COMMUNITY BOARD FEEDBACK PACKAGE

Business Name: RISE BAR

Cafe Address: 859 9TH AVE, NEW YORK, NY, 10019

Application Number: 20240722010015

***SUPERSEDED**

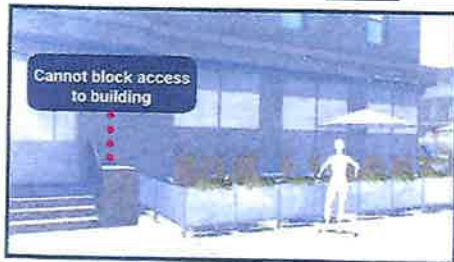
The proposed Site Plan does not provide for the required 8 foot pedestrian clear path at the north end of the cafe. The applicant has agreed to remove 1 table with 3 seats at the north end of the cafe to provide for the required clear path. See attached Revised Site Plan

To provide for the required 8 foot pedestrian clear path, MCB4 request that 1 table with 3 seats at the north end of the cafe be removed. The applicant has agreed to this change and provided the attached Revised Site Plan.
